LIGO-T040096-02-R

Upper-Intermediate Mass for ETM Controls Prototype Quad Pendulum
Suspension

Product Design Specification

QUESTIONS FOR DESIGN MEETING 013, MONDAY JUNE 28TH 2004

Problem: Limited space on U-I Mass bottom plate causes interference between blades and the suspended mass wire clamps.

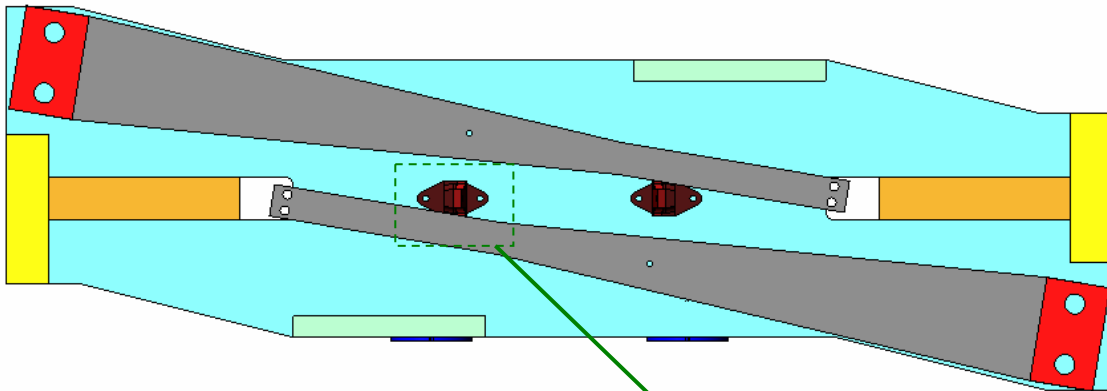
Calum recommends that we need to have 2-3mm between the blade and the wire clamp to allow for alignment and adjustment.

INTERFERENCE!

1) Reduce the 'n1' (half separation of the break-offs in y-dir) from 70mm to 50mm:

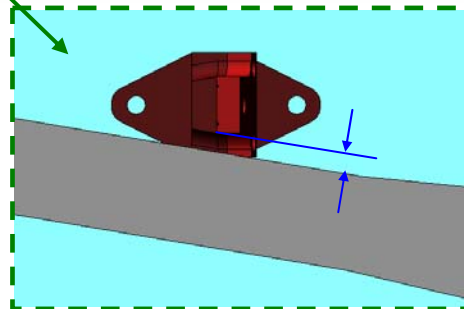
Distance between blade and wire-clamp: 2.96mm

- i. Can this be done without affecting the suspension performance?

>>>> I need to know whether it would be possible to reduce the n1 value
 >>>> on the Quad to 50mm from 70mm. The problem is that with the current
 >>>> layout the blade will interfere with the clamp. Calum thought that
 >>>> reducing n1 to 50mm shouldn't affect suspension performance greatly
 >>>> considering that the n0 is 200mm.

>>> Changing n1 to 0.05 and also l1 to 0.313 (from 0.304) to keep
 >>> overall length of quad the same does have a slight adverse affect on
 >>> the yaw. The frequencies are Ok but coupling to the highest mode

>>> (at around 3.1 Hz) gets worse - typically the Q doubles. Although
>>> this isnt directly affecting the settling time, which is dominated
>>> by the lowest mode, I am musing about whether there could be any
>>> problems (for example applying Ken's latest ideas about damping as
>>> combination of active for the low freqs and ECD for the higher
>>> ones). I want to muse a bit longer. Will get back to you soon.

>> I wanted to ask if making n1 0.06 is enough of a change to fit in
>> wire clamps - it gives a less significant change to the yaw
>> behaviour. I am still musing on whether the 0.05 is acceptable but
>> thought i would ask anyway.

> As we are looking at altering the blade to having a narrower tip it is
> not necessary to move the break-off as far from the 0.07m as I
> proposed. I have checked the model - moving the wire clamp to 0.06
> from the centre of mass - and this seems to be okay.

> We can stick with this value and forget about moving to the 0.05m.

That's good! Let's settle for n1 = 0.06. I'll check what l1 has to be to
keep overall length same.

It is best that a combination of solutions proposed in 1 and 3 are adopted for the design.

- Use a narrow blade design with #8-32 holes along the length of the blade.
- Reduce n1 to 60mm.

2) Angle blades further. Diagram shows increase from 9.5degrees to 12degrees:

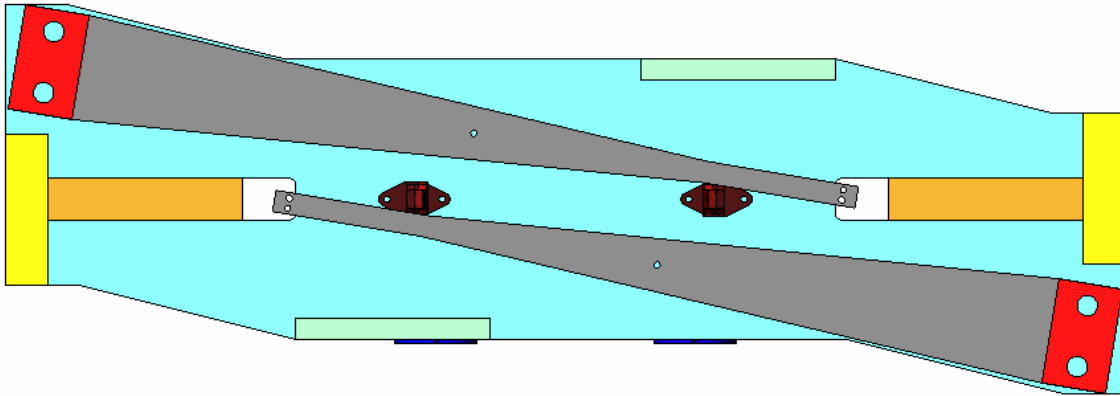
Distance between blade and wire-clamp: 2.56 mm

NOTE: Blades 11degrees gave a distance between the blade and clamp of 1.42mm

- i. Off-axis Moments (Lxy, Lyx, highlighted in **RED**) increase such that they are higher than Moments in the Y plane (Lyy).
- ii. Norna – I expect that this is not good?!

3) Reduce blade width at tip to 10mm:

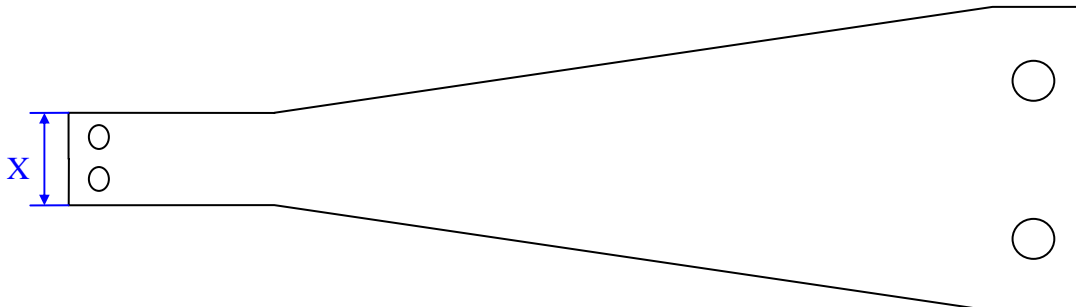
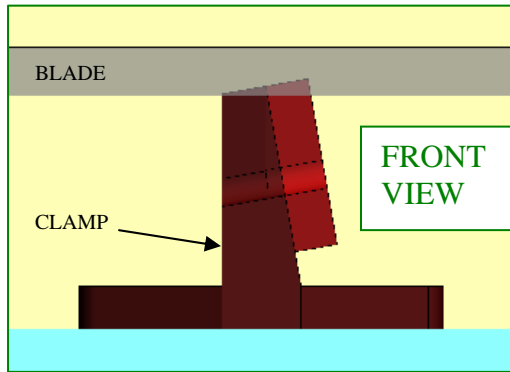
Distance between blade and wire-clamp: 2.16 mm

```
>>>Would it be okay to move to a 10mm width at the thin end instead of
>>>15mm?
```

```
>>To answer your question about the blades. It sounds like the design
>>you are proposing has a trapezoidal shape. Is this correct? I suppose
>>the issue then is how much material there is around the holes drilled
>>for the clamp. If the holes are one behind the other then 10 mm width
>>is probably OK. Of course the spring constant of the blade will be
>>slightly
>> different with this revised shape but it is hard to say how much it
```

However, I want to change these to bolts #4-40 bolts (2.8mm DIA) and a width of X=10mm.

1. The bolts are strong enough for the loads involved
2. The bolt heads do not interfere. (I would think that the holes must be drilled fairly close to the edge for this not to be a problem, unless you envisage a special clamp design).

- i. Is this going to affect the blade performance? Shouldn't be a problem – Comments from DM013.
- ii. Can we use #4-40 bolts for the blade wire clamp? Probably be okay (original BWC concepts has #2-56 but deemed fiddly to work with) but maybe we could use #8-32 but position the holes along the blade.

NOTE: #4-40 Socket Head bolts have a maximum head diameter of 0.183in (4.65mm) therefore two can fit laterally on a 10mm blade tip.

4) Raise Blades to Avoid Interference:

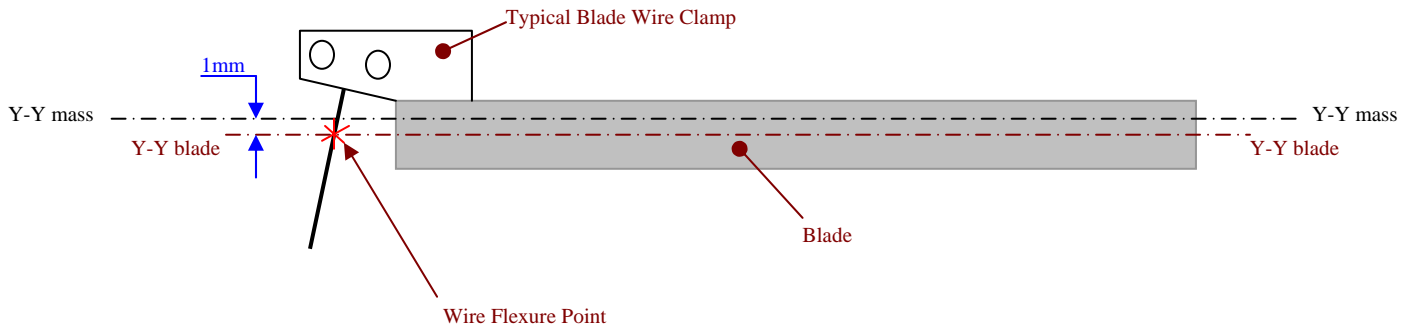
The blade collides with the clamp in the Y-Z plane by around 1.5mm. Could we raise the height of the blade to avoid this interference (adjusting for the break-off height via the blade wire clamp)?

- i. As the blade is not guaranteed to be perfectly flat under load, there is still a possibility that the blade will hit the clamp when loaded.
- ii. Moving the blade from the default position, and compensating with the clamp, will cause a cross coupling which will in-turn affect the suspension performance.
